Project	**IEEE 802.16 Broadband Wireless Access Working Group <http://ieee802.org/16>**
Title	**A Proposal for the Removal of the PDE bit from the 802.16.1 MAC Generic Header**
Date Submitted	**2001-03-08**

A Proposal for the Removal of the PDE bit from the 802.16.1 MAC Generic Header

Figure 1Downlink Generic Header

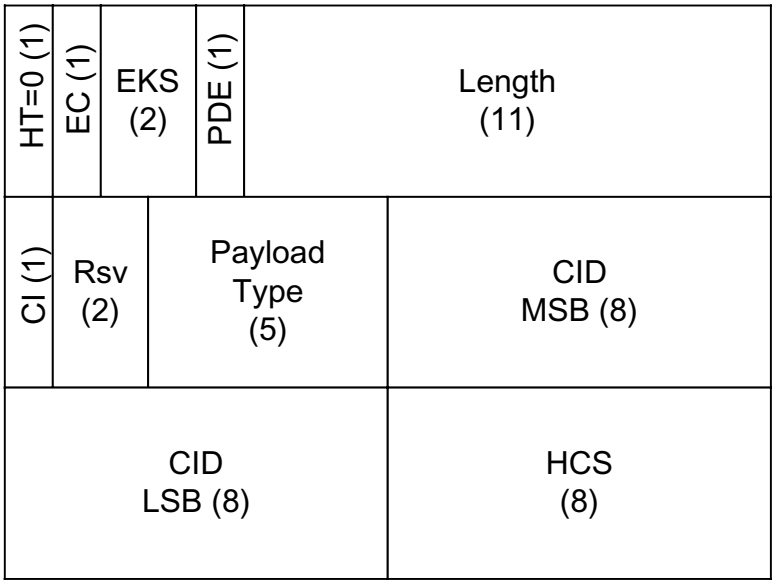
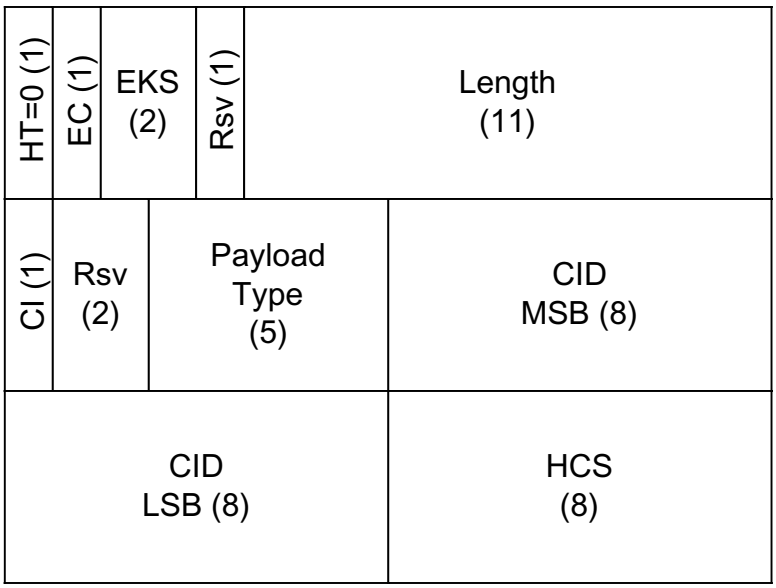
The Generic Header (GH) is required for all data transmissions over the air. Therefore, a premium is placed on all bits within this header as it represents fixed overhead. The PDE bit is used to mark an MPDU as being eligible for discard. However the bit cannot be acted upon until the packet has already been sent over the air link. Given the implementation specific value of this functionality, it is desirable that the PDE bit reverts to a reserved bit and that the PDE functionality be included within a specific packet type. In other words, the new type field can be used to indicate the presence of a PDE bit in a TBD header addition.

The following diagrams show the GH with the removal of the PDE bit.
